UCSF building seismic ratings

1701 Divisadero, MOB 2

CAAN #2036

DATE: 2020-06-26

Figure 3: Moment frame beam-column connection

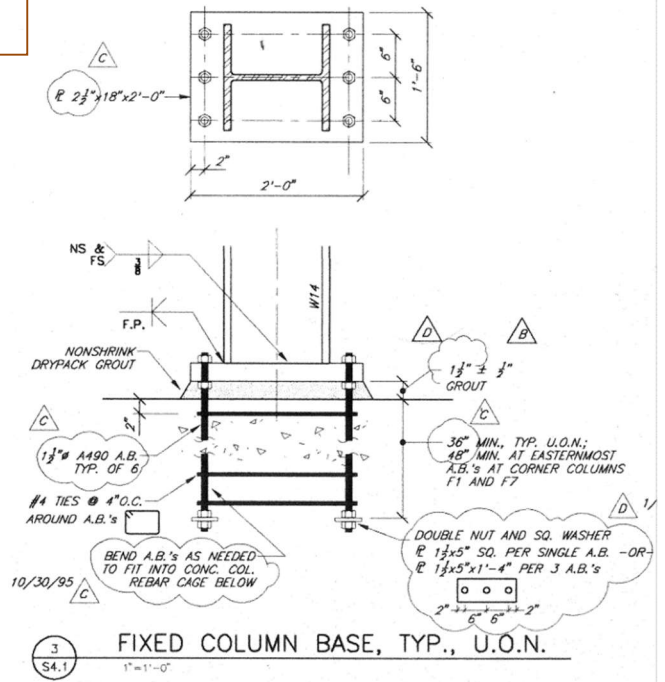
Structural feature or potential deficiency	Finding/notes
Welded moment connections	The steel moment-resisting frame connections use welded beam flange cover plates as shown in Figure 3 below. Because of the cover plates, this connection configuration is significantly stiffer and stronger than a typical pre-Northridge welded steel moment frame where the ends of the beam flanges are unreinforced. It is likely that the beam flange reinforcement will protect the connection by forcing flexural yielding in the beams to occur away from the welded connections. This connection configuration is different, however, from the prequalified welded flange plate connection in FEMA 350 (2000) and there is no prequalified welded flange plate connection in AISC 358-16. This may be because there are concerns about the reliability of this connection compared to the connection types that are prequalified. We expect that the ductility capacity of the connections is substantially greater than that of typical pre-Northridge connections, however there is still a potential for connection fracture under earthquake action.

Moment frame connection panel zone strength	The panel zones in 31 of 42 connections that were checked in this Tier 1 evaluation do not have enough capacity to resist 80% of the maximum shear demand that can be placed on them by adjacent beams. Demand to capacity ratios were as high as 3.0. Panel zone yielding during a strong earthquake would lead to softening of the moment-resisting frames, increasing inter-story drifts and increasing the likelihood of damage, e.g., to cladding and partitions.
Inter-story drift	Inter-story drift ratios exceed the Tier 1 drift check 3% limit in the lower stories in the north-south direction. Increased inter-story drift would lead to increased building damage.
1 st floor offset	Below the 1 st floor, lateral resistance is provided by concrete walls, primarily at the perimeter of the parking areas at lines 1, 7, A, and F. The steel moment-resisting frame above the 1st floor on Line B (the west façade of the building) is in-line with an 8" thick concrete wall below that is of insufficient size to resist shear demands that could be delivered by the moment frame. The steel moment-resisting frame on Line 3 does not have a wall in line with it in the parking levels below. Shears from the Line 7 and Line 3 moment frames therefore are to be carried through the 1st floor slab to the below-grade perimeter walls. Diaphragm stresses at the 1 st floor have not been evaluated as part of this Tier 1 study. Furthermore, the offset of the above-ground stories with respect to the parking floors below-ground results in plan torsion that effects wall shear demands. The Tier 1 quick check of wall shears indicates that seismic demand-capacity ratios are low, however, (0.2 to 0.5) indicating that this torsion effect will not adversely affect the building's seismic performance.

(4) AT W21 & W24 MOMENT FRAME GIRDERS, EXTEND TAB PLATE TO BOTTOM FLANGE AND WELD.

As-built drawings indicate alternate detail was not used.

Note on shear tab detail 2/S1.2

SRC members had concerns about the column base plates (Figure 4) that do not provide full fixity for the columns. SRC members also felt that that the frame was light and were concerned about the weak panel zones and uncertainty about how effective the cover-plated connections would be.

Column splices occur 4' above 3rd floor level

All moment columns:
W14x132

Base plate detail at perimeter moment frames only. (Not used at Line 3.)
